# *Calculating New Melones Reservoir Release Dilution Credits*

Suggestions based on the 2010 Reclamation MAA Documents
RT Brown, ICF International ( “should be” and “should not be” are the author’s views)
August 13, 2010

Figure 1. Monthly Historical Flow (cfs) and EC (µS/cm) at Maze and at Vernalis for 1976-1991.

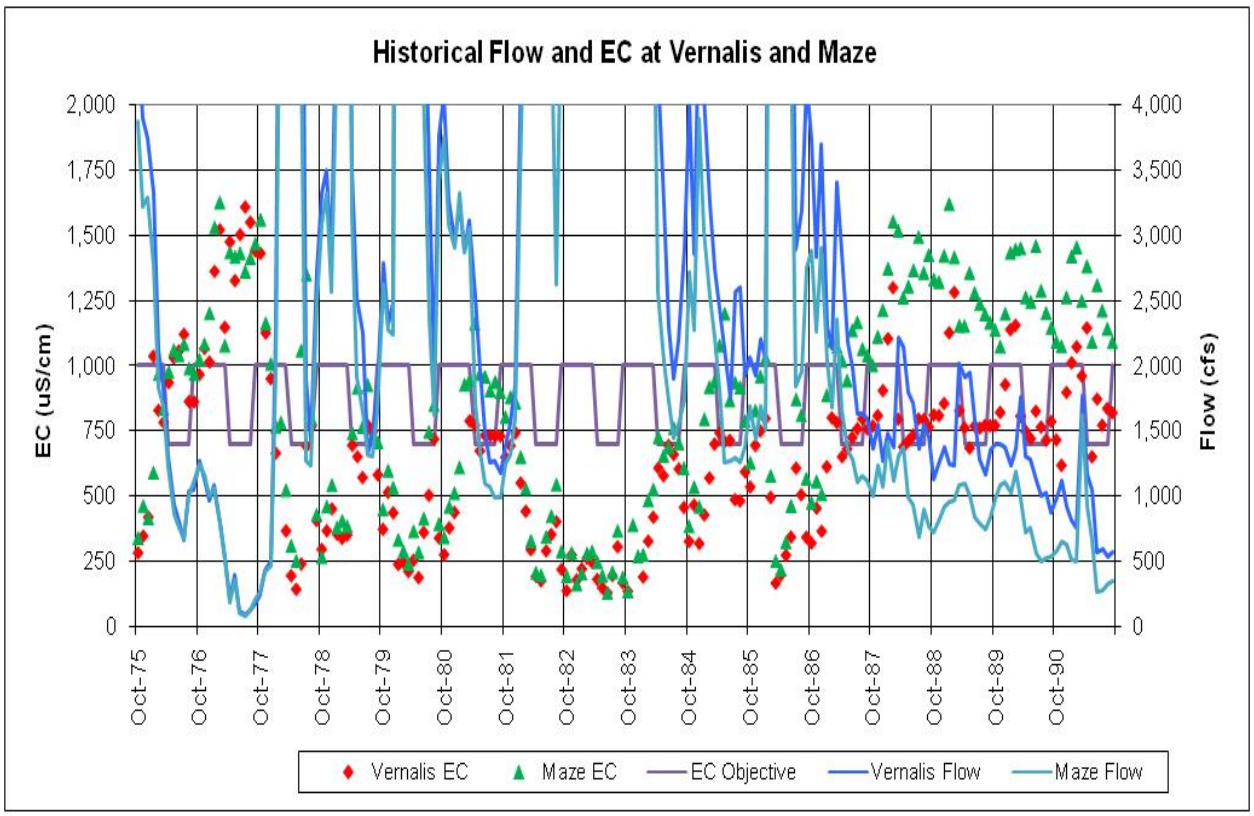
Figure 1 shows the monthly Maze and Vernalis flows and EC data for WY 1976-1991, which is the standard period of DSM2 simulations often used to describe the range of Delta EC conditions in planning studies (e.g., South Delta Improvements Program and the OCAP BA alternatives). The flow at Vernalis (dark blue line) is always higher than the flow at Maze (light blue line) because the Stanislaus River enters the San Joaquin River between these two stations. The Vernalis EC (red diamonds) is always

lower than the EC at Maze (green triangles) because the Stanislaus River EC is about 100 uS/cm and always provides a dilution effect at Vernalis. During 1976 and 1977 there was low SJR flow at Maze (less than 1,000 cfs) and almost no increase at Vernalis. But during the 1988-1991 period when SJR flow at Maze was less than 1,000 cfs, there was (beginning in March) about 250-500 cfs added by New Melones Reservoir releases to dilute the SJR EC to the required EC objective of about 750 uS/cm (500 mg/l TDS required in D-1422). The 1995 WQCP Vernalis EC objectives (purple line) are shown for reference in Figure 1, although this was not the Vernalis EC objective during this 1976-1991 period. During months with higher Maze flows (more than 2,000 cfs), the Maze EC was already less than the Vernalis EC objectives and there was no need for dilution flows to meet the EC objectives.

Figure 2. Estimated Stanislaus River Flow needed to meet Vernalis EC objectives for 1976-1991.

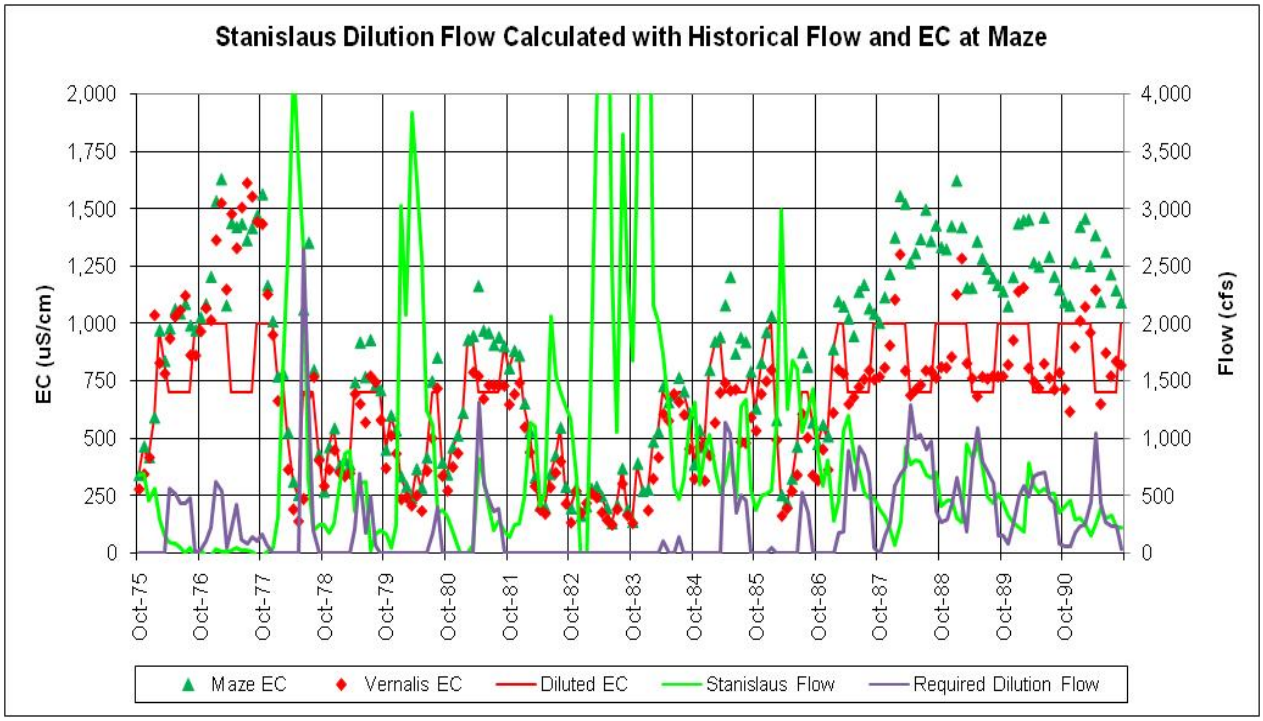
Figure 2 shows the estimated Stanislaus River dilution flow needed to meet the Vernalis EC objectives for the historical Maze flow (cfs) and Maze EC (uS/cm) for water years 1976-1991. When the Maze EC is less than the Vernalis EC objective, there is no dilution flow needed. When the Maze EC is higher than the Vernalis EC objective, the necessary dilution flow is calculated as:

Needed Stanislaus Flow (cfs) = Maze Flow x (Maze EC – EC Objective) / (EC objective – Stanislaus EC)

The Stanislaus EC was assumed to be 100 uS/cm. More dilution flow is needed when the Maze flow is high, but only when the Maze EC is higher than the EC objective. The calculated dilution flow (purple line) was often 500-1,000 cfs in the low flow months when the EC objective is 700 uS/cm. The historical Stanislaus River flows (green line) were generally higher than the required dilutions flows. During wet years (when New Melones Reservoir is filled), the Stanislaus river flows were often higher than necessary for salt dilution. The assimilative capacity credit should be calculated only for the dilution flow required to meet the Vernalis EC objectives:

Assimilative Capacity Credit (tons) = Stanislaus Flow (cfs) x (EC objective – Stanislaus EC) x conversion

Figure 3. Calculated Assimilative Capacity TMDL Credit (tons) for Stanislaus Releases Required to meet the Vernalis EC Objectives.

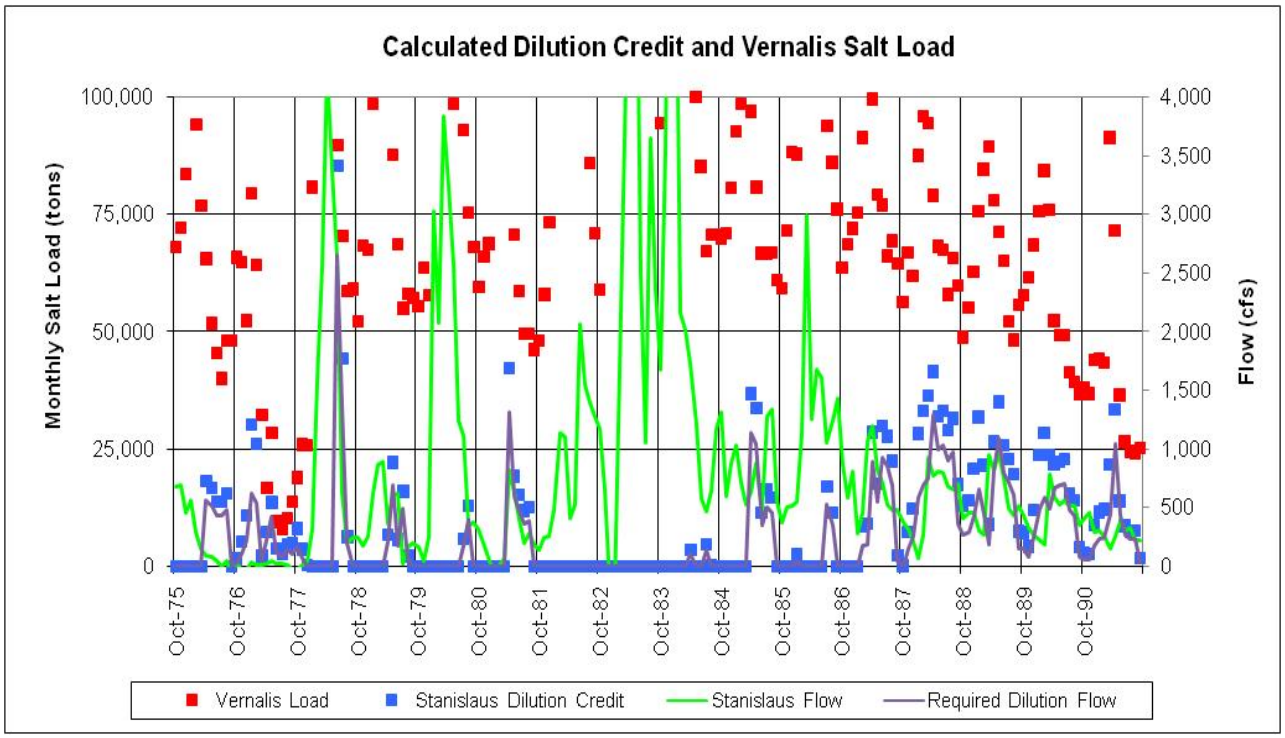
Figure 3 shows the calculated monthly Vernalis salt load (tons) and the corresponding Stanislaus release credit (tons) for the historical flow and salinity measured at Maze for 1976-1991. The monthly Vernalis salt loads were about 50,000 to 100,000 tons during the summer irrigation season in most years. The

monthly salt loads were less than 50,000 tons in 1977 and in 1990 and 1991 because of low deliveries and low seepage sources. The calculated assimilative capacity credits were about 20,000 to 30,000 tons in months when calculated Stanislaus TMDL releases were 500 to 1,000 cfs. These Stanislaus TMDL assimilative capacity credits are a great benefit for implementing the TMDL to match the existing salt loads in the San Joaquin River with sufficient flows to meet the Vernalis EC objectives. But calculating an assimilative capacity credit for every month of releases from New Melones Reservoir is not appropriate.

Figure 4. Historical Flow (cfs) and EC (uS/cm) and Calculated Salt Load (tons) at Vernalis for 1976-1991.

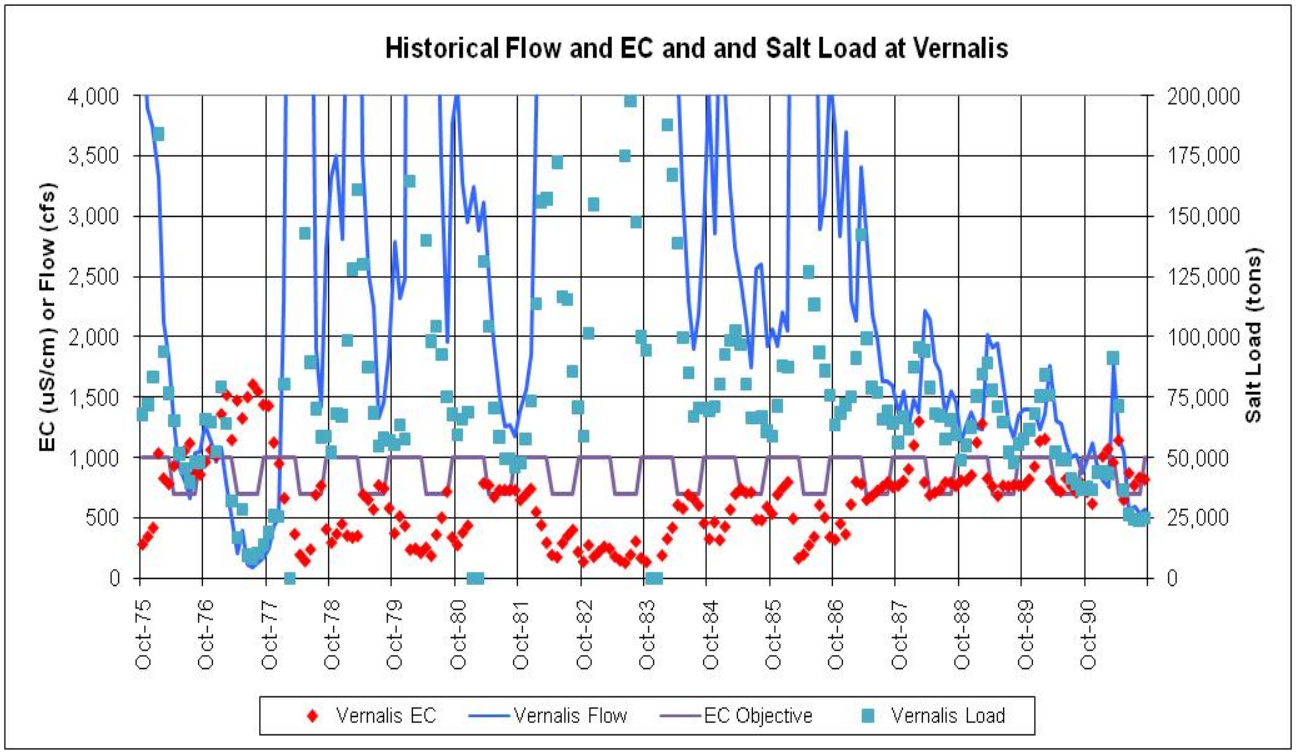
Figure 4 shows the historical Vernalis flow, EC and calculated salt load for WY 1976-1991. This figure illustrates the difficulty of TMDL management without always identifying the source of the loads. Only high concentrations of salt (or other contaminants) cause an impact to beneficial uses. Loads that may be high because of high flows do not need to be managed or regulated. This figure also summarizes the important role of flow management for reducing the salinity (or contaminant concentration) to the water quality objectives. Reducing the salt load from other beneficial activities, such as irrigation for agriculture or wastewater from urban areas, will not likely prove successful. When the SJR salinity is relatively high, the most practical management action will likely be flow management.

Figure 4 illustrates the TMDL implementation options and the purpose of the MAA. The overall goal of the TMDL is to meet the Vernalis EC objectives. The purpose of the monthly accounting of individual flows and salt loads that contribute to the Vernalis salt load is to identify excess salt loads that can be reduced or shifted in time. However, it is difficult to accurately account for the many sources of salt within the lower SJR basin. This is the motivation for the SJR WARMF watershed model that is being used to guide the CV-SALTS program. The MAA represents Reclamation's share of the flow and salt accounting within the lower SJR. A TMDL implementation report should be prepared by RWQCB staff to clarify these linked flow and salt accounting and management issues for all stakeholders.
